Groundwater Transfer Review Summary Form

Transfer/PA # T- 14740

Application: T-14740

Applicant Name: Pegg Industries, LLC

Map

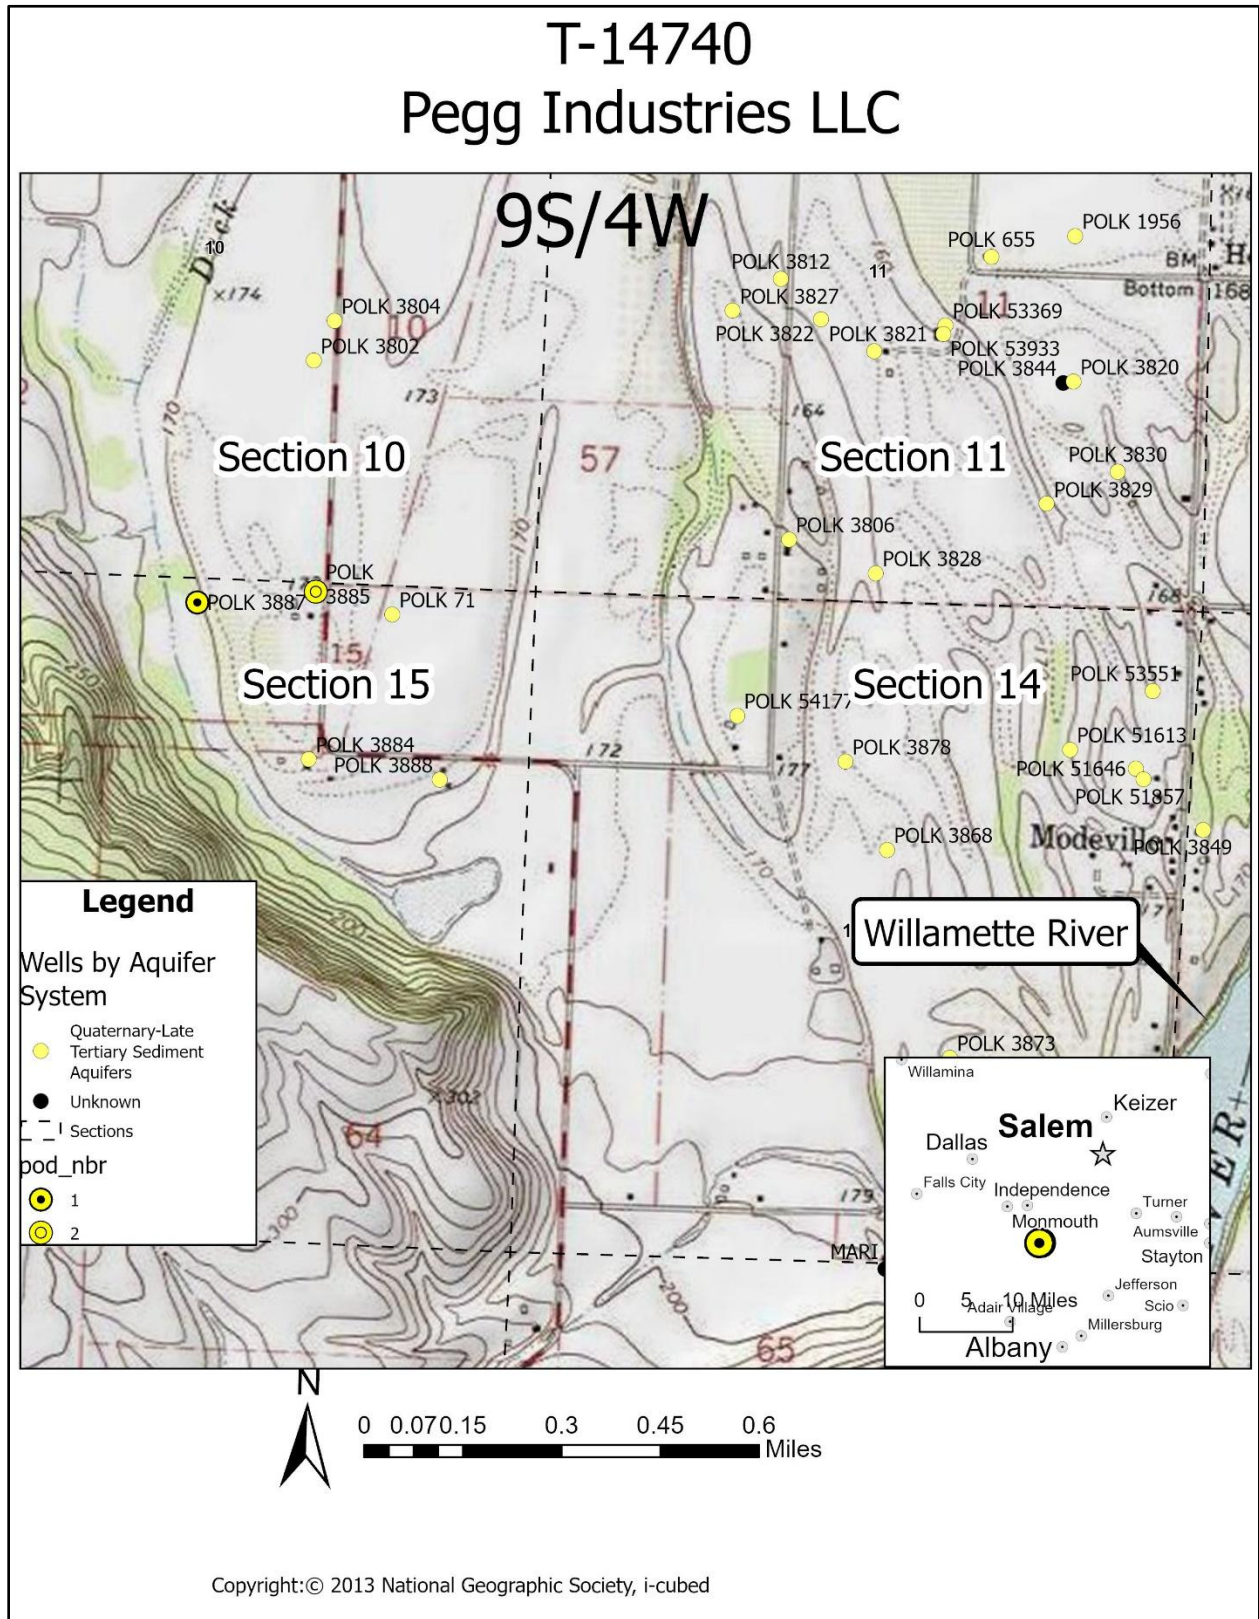
Yes No Comments: The proposed APOA, POA 2/Well #2 (POLK 3885), is closer to the Willamette River than the authorized POA, POA 1/Well#1 (POLK 3887). The reduced intervening distance is anticipated to result in an increase in interference with the Willamette River.

Provide context for minimal/significant impact: The reduced intervening distance is relatively small compared to the overall distance between the POAs and the surface water source such that there is not a significant difference in the propagation of interference anticipated.

Theis Drawdown Analysis: POA 1/Well#1 (POLK 3887)-POLK 71

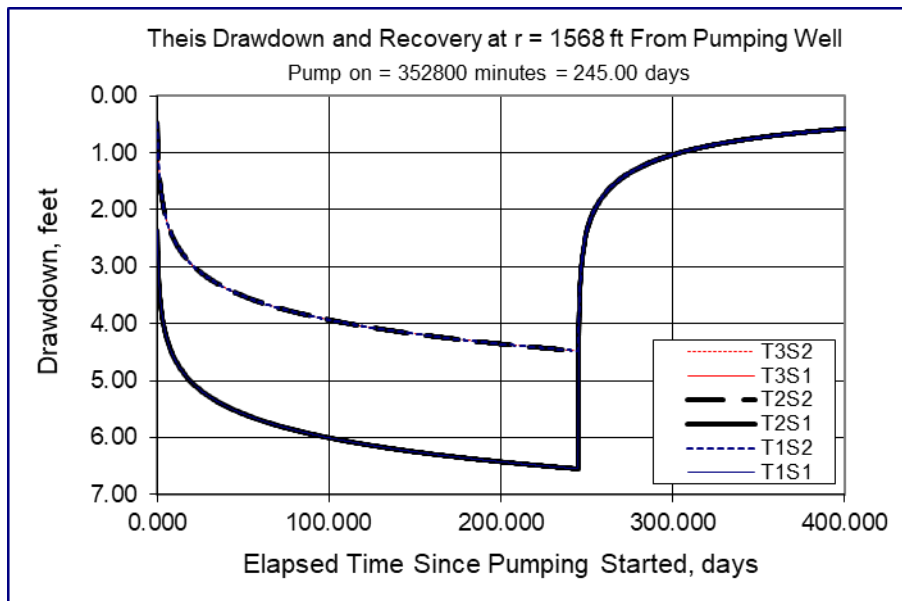
5. a) Will this proposed change, at its maximum allowed rate of use, likely result in an increase in interference with **another ground water right**?
 - Yes No Comments: The proposed APOA, POA 2/Well #2 (POLK 3885), is closer to POLK 71 than the authorized POA, POA 1/Well#1 (POLK 3887). POLK 71 is a POA on Certificate 97872 with priority date 8/23/1990. The reduced intervening distance is anticipated to result in an increase in interference with POLK 71.
 - b) If yes, would this proposed change, at its maximum allowed rate of use, likely result in another groundwater right not receiving the water to which it is legally entitled?
 - Yes No If yes, explain: It is not likely that the pumping by POA 2/ proposed transfer will POA 2/Well #2 (POLK 3885) will result in POLK 71 not receiving the water to which it is legally entitled, see attached Theis Drawdown and Injury analyses.
